Subdivision
Tracts A-1-A, A-1-B, A-1-C, A-1-D, A-1-E & A-1-F
Los Pastores Shopping Center
 Elena Gallegos Grant, Projected Section 31, Township 11 North, Range 4 East, N.M.P.M.
 Albuquerque, Bernalillo County, New Mexico
 April 2016

RE: Starbucks at 4601 Wyoming Blvd NE
Grading and Drainage Plan
Engineer's Stamp Date 2-1-2017 (File: F19D013C)

Project #:BP-2016-32291 (File: F19D013C) Case #: 16DRB-70420 and 16EPC-40040
City Engineer's comments dated January 24, 2017 (attached)

RE: Starbucks at 4601 Wyoming Blvd NE
Grading and Drainage Plan
Engineer's Stamp Date 1-9-2017 (File: F19D013C)

Blanket easement screenshot from recorded plat shown below:

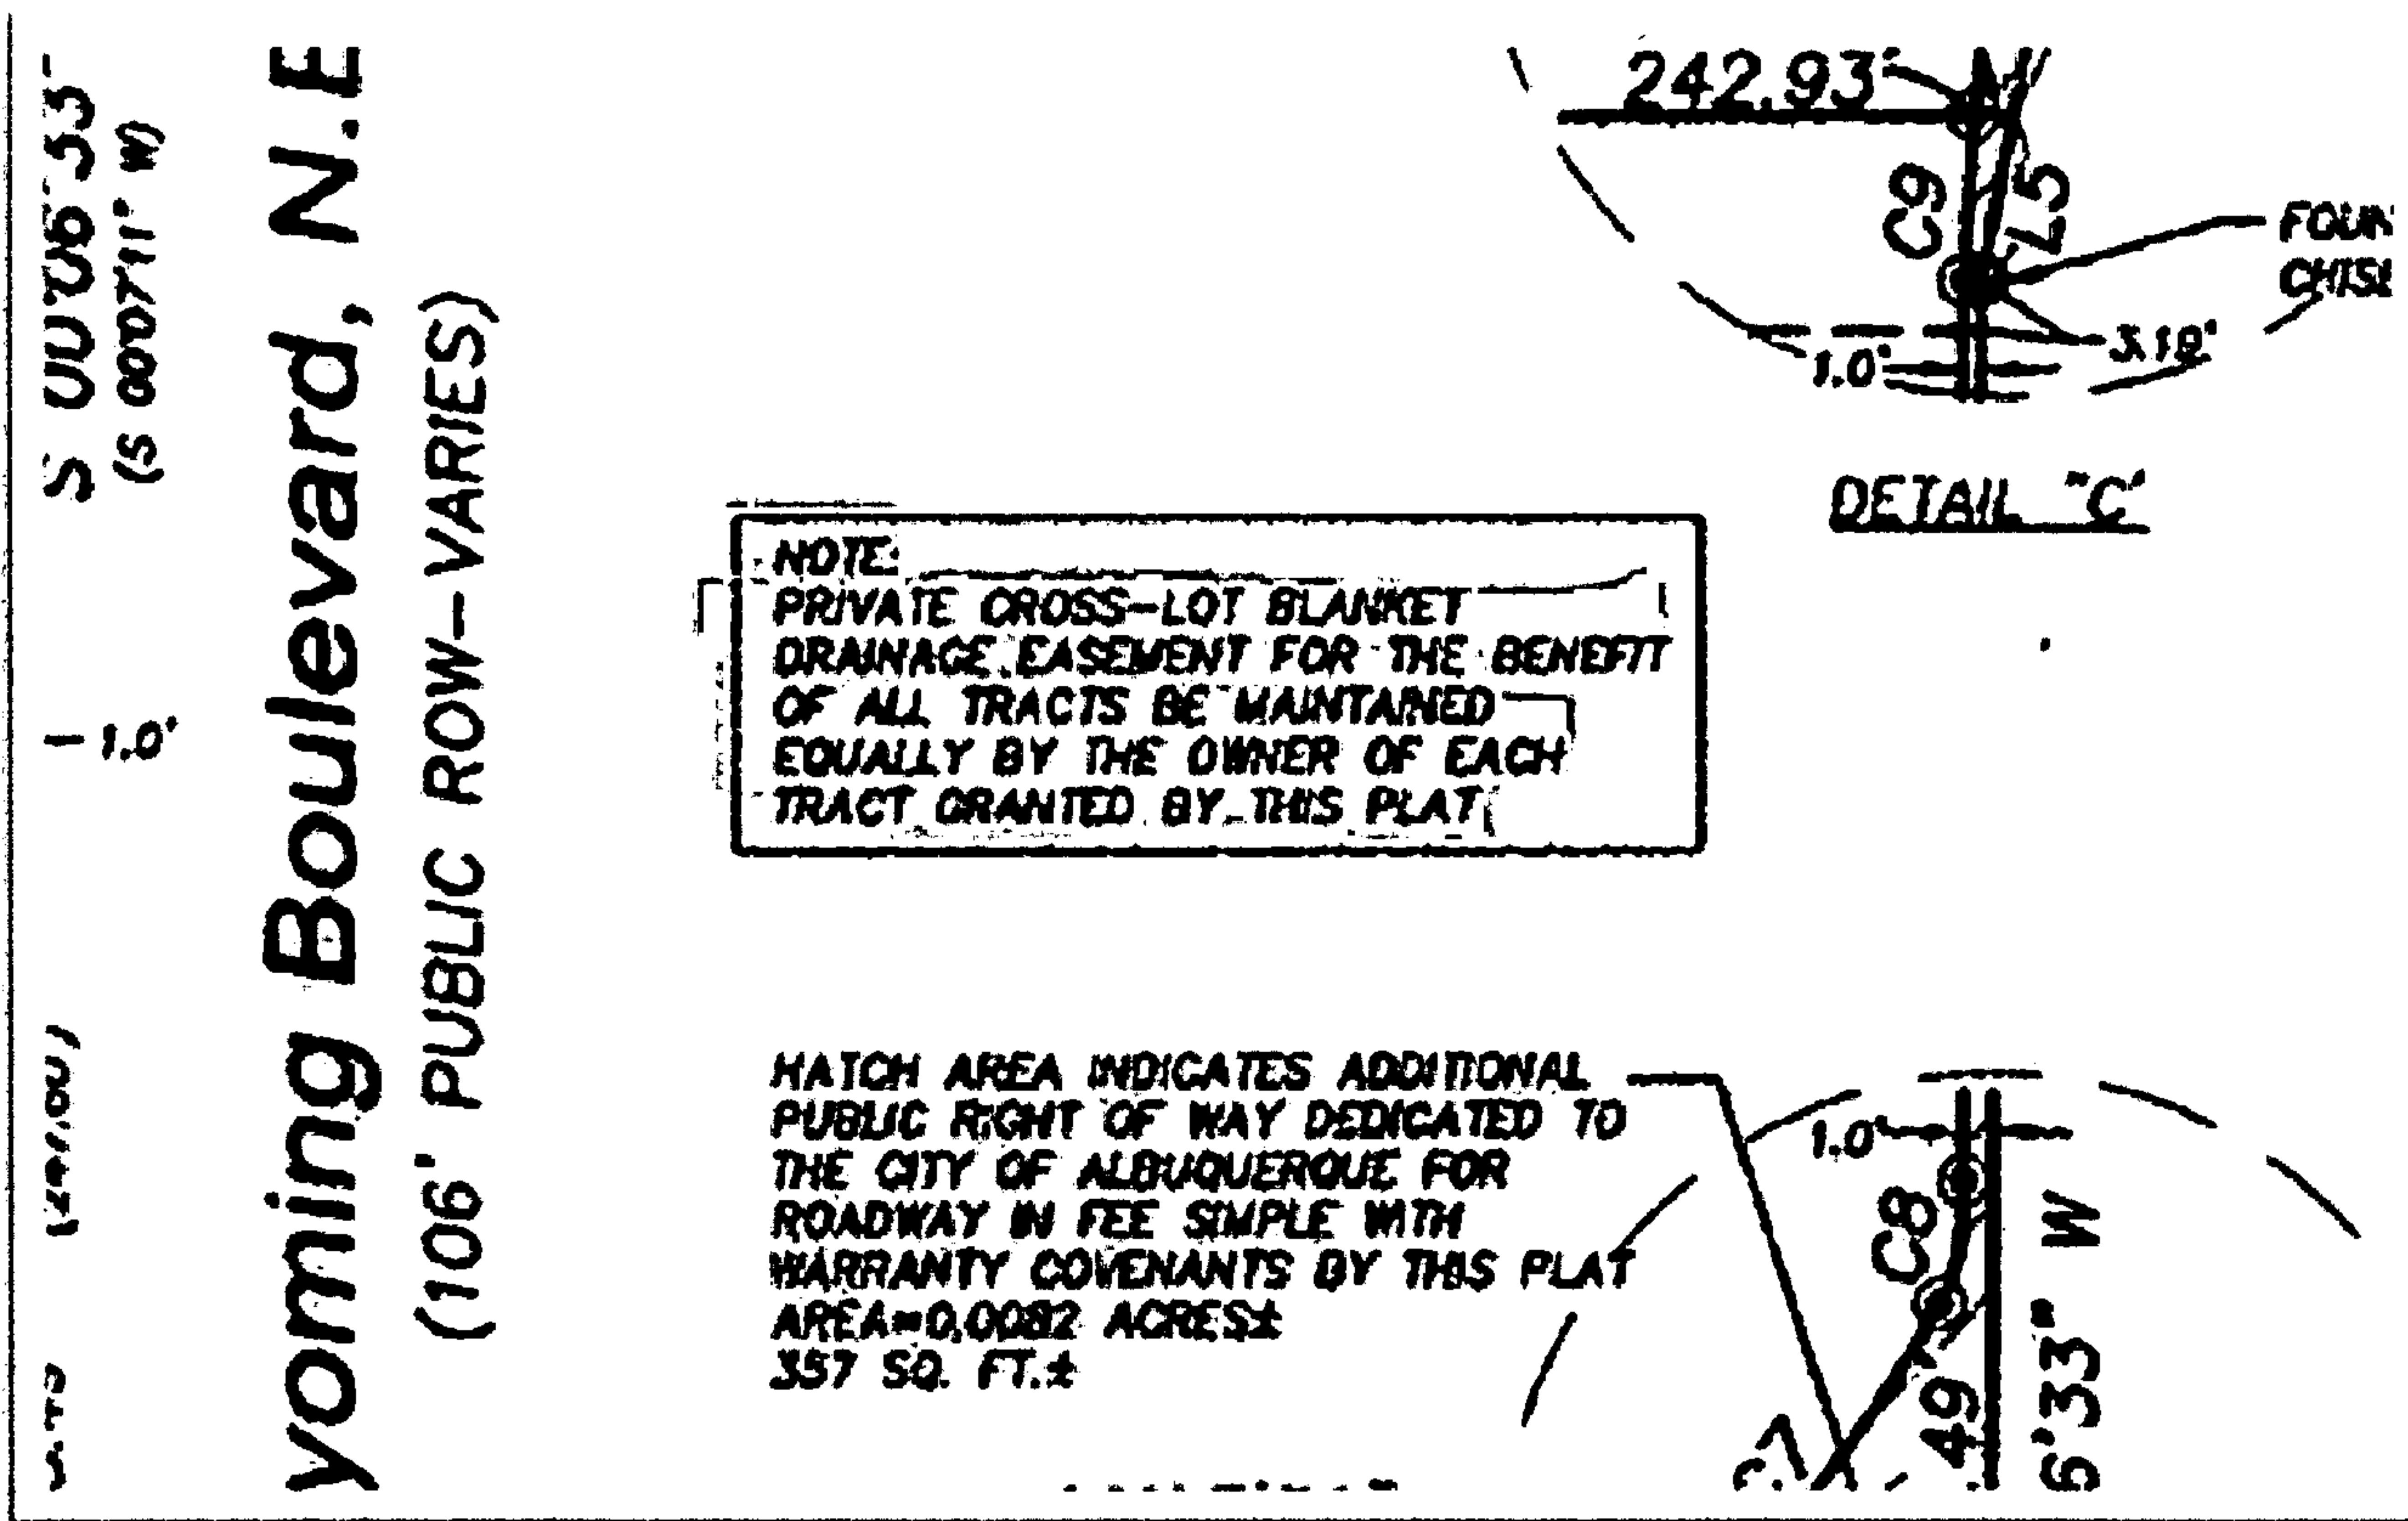
Regarding comment 2:

Attached plans show the grades, inverts and other utility crossings. Regarding the easement, the recorded plat with all the easements is in ePlan Documents folder with the name: *Los Pastores Recorded Plat.pdf*. See further below for a screen shot of the blanket easement for underground utilities, which can be found on page 3 or recorded plat. Will this easement suffice for easement document requested in comment 2?

Refer to page 3 of *Los Pastores Recorded Plat.pdf* previously uploaded to Documents folder. Blanket easement box note located near center of page 3 notes: "Private cross-lot blanket drainage easement for the benefit of all tracts be maintained equally by the owner of each tract granted by this plat"
